MOIR STREET COLLECTIVE

Oral Presentation in support of sumissions on the WCC District Plan Review

Stream 4: Centres

29 June 2023

WINTER SOLISTICE

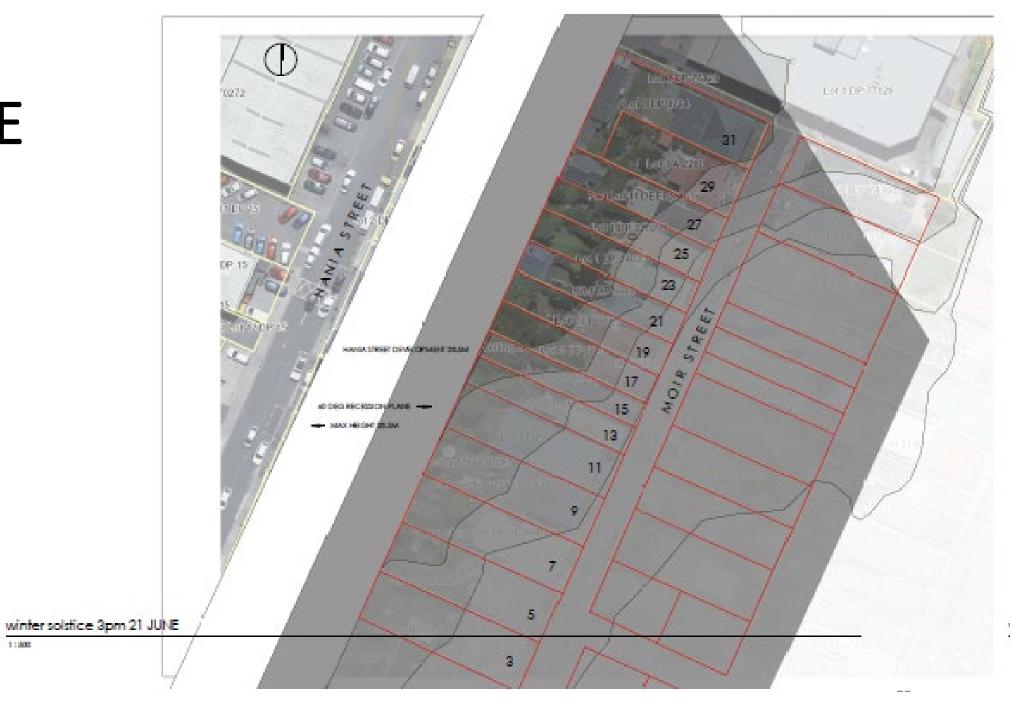
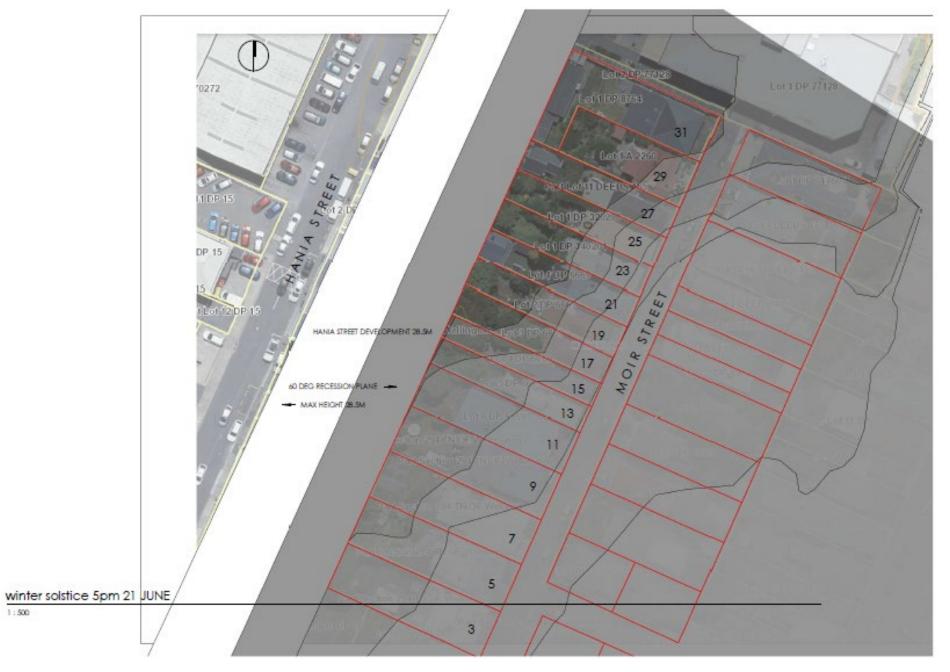
PRIMARY CONCERN 28.5m high development in CCZ

= 8-10 STOREY **DEVELOPMENT ON** HANIA STREET IMMEDIATELY ADJACENT TO OUR **PROPERTIES**

- Contrary to objectives and policies of the draft plan.
- Cannot mitigate this scale of development through design controls
- No assessment of effects by WCC of the adverse effects on Moir Street.
- Where is the expert evidence to confirm no adverse effects?
- WCC Boffa Miskell evidence supports concerns

Significant adverse effects

- Heritage
- Sunlight
- Shading
- Character
- Streetscape and over dominance
- Noise
- Privacy
- Wind

- *Reasonable* height: 15m height limit
- Reasonable setback: The first 5 metres back from the boundary must not exceed 4m (1 story)
- *Reasonable* recession plane: 5m and then 60 degrees
